Comments & Instructions
for Insertions to the Mining & Reclamation Plan
of the Wellington Preparation Plant
C/007/012

Deficiency Response

March 31, 2008

Submitted to the State of Utah, Division of Oil, Gas & Mining

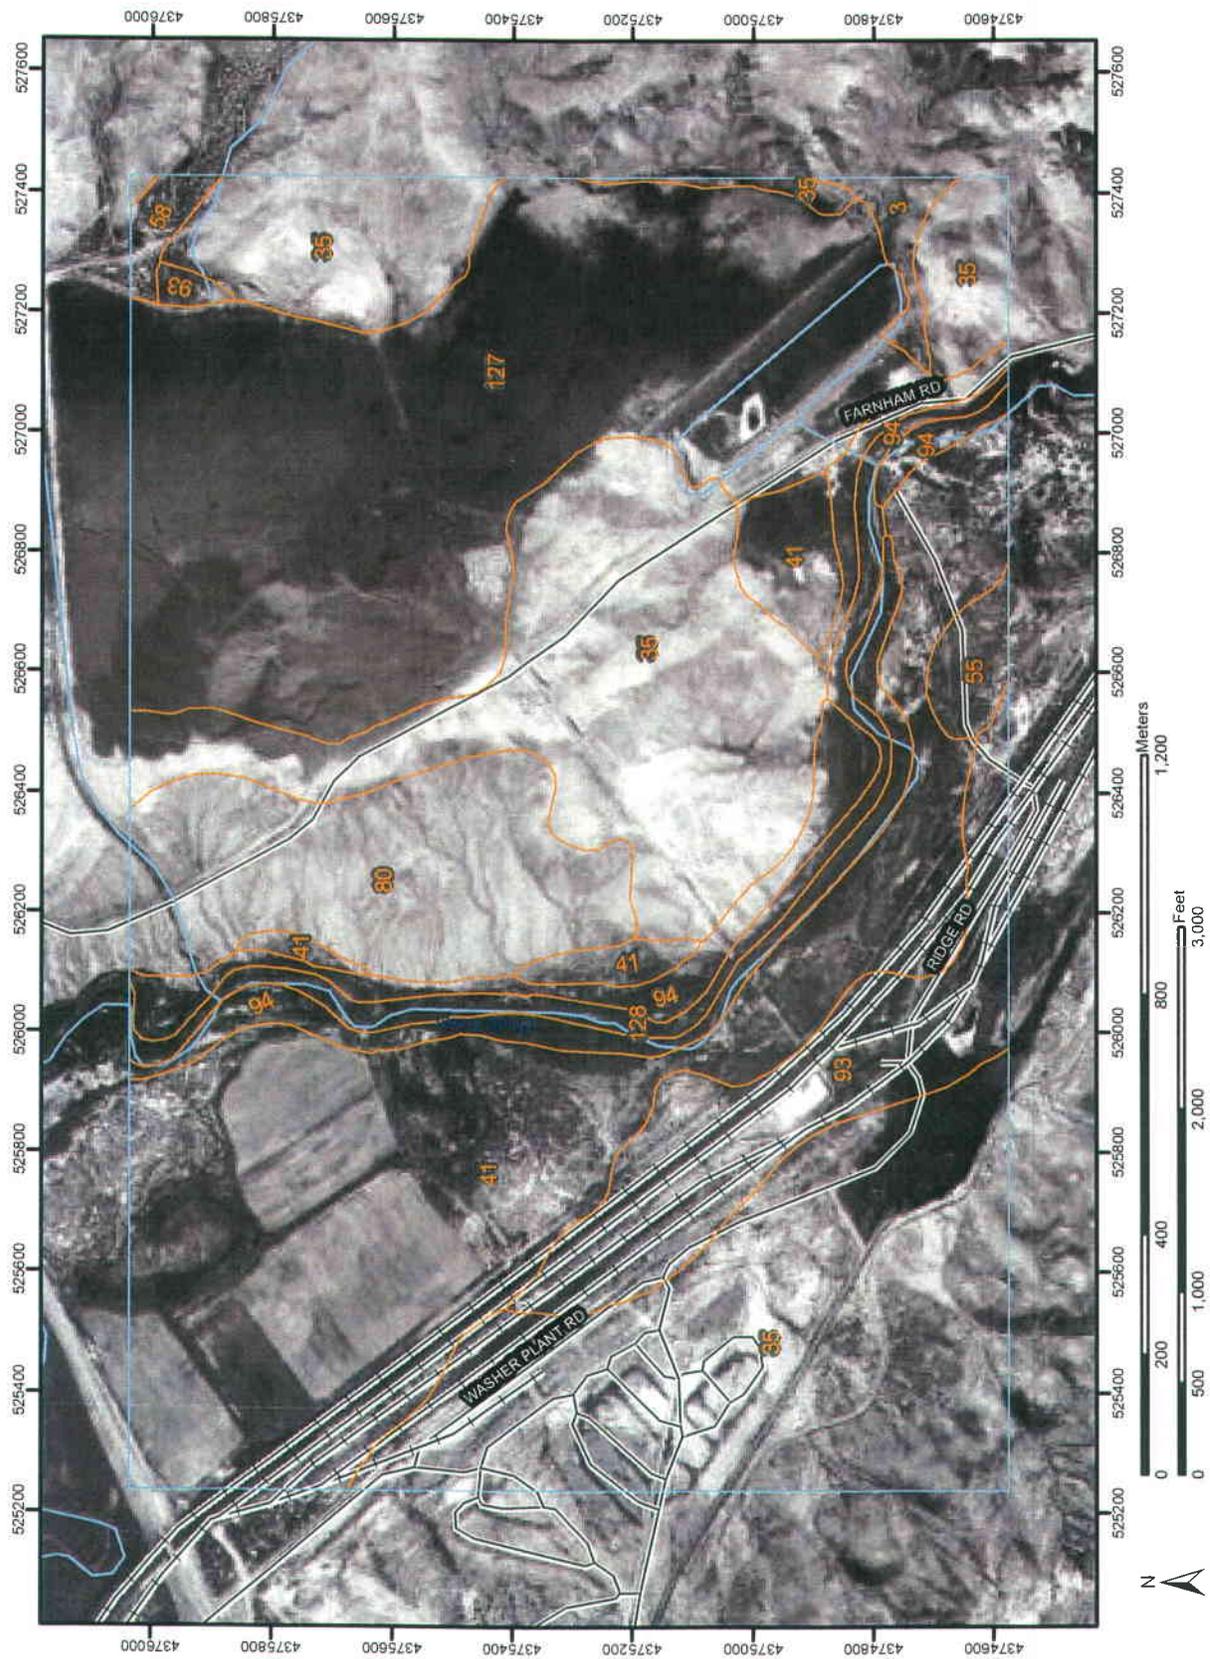
R645-301-541.400 and R645-301-542, The reclamation must include (certified) maps or drawings or other information to show the location of the reclamation disturbance and how the Permittee will comply with environmental protection standards or a timetable for reclamation.

Reclamation of the area has been described in Response "E" above. In the description provided above regarding sealing of the pipeline it is stated that the exact location for these activities will only be known at that time. Consequently, certified as-built maps with the location of these activities will be provided at that time.
